BRUNSWICK STEAM ELECTRIC PLANT, UNIT NOS. 1 AND 2  
DOCKET NOS. 50-325 AND 50-324/LICENSE NOS. DPR-71 AND DPR-62  
RESPONSE TO REQUEST FOR ADDITIONAL INFORMATION REGARDING  
REQUEST FOR LICENSE AMENDMENTS - EXTENDED POWER UPRATE  
(NRC TAC NOS. MB2700 AND MB2701)

Response to Request For Additional Information (RAI) 10

Response to Request For Additional Information (RAI) 10

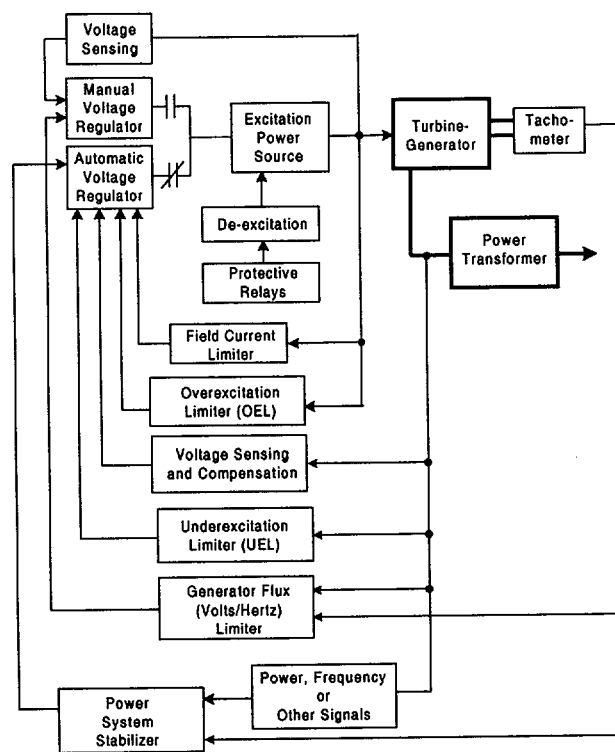
Provide in detail the damping of the post-transient oscillations of the Power System Stabilizer including the schematics. The response should also show how much reactive power (MVARs) is being provided by the power system stabilizer. Does it use the FACTS technology?

Power System Stabilizer (PSS) is a supplementary control that is input to the excitation system to provide damping to power system oscillations. The inputs are those signals in which the oscillations are observable, such as speed (i.e., frequency) and power. The PSS input has the appropriate phase compensation to modulate field voltage such that torques are generated that are out of phase with those causing the power oscillations. The PSS acts to damp out these oscillations in both normal and contingency conditions. The following provides a simplified schematic of the PSS modification in relation to the existing generator controls.
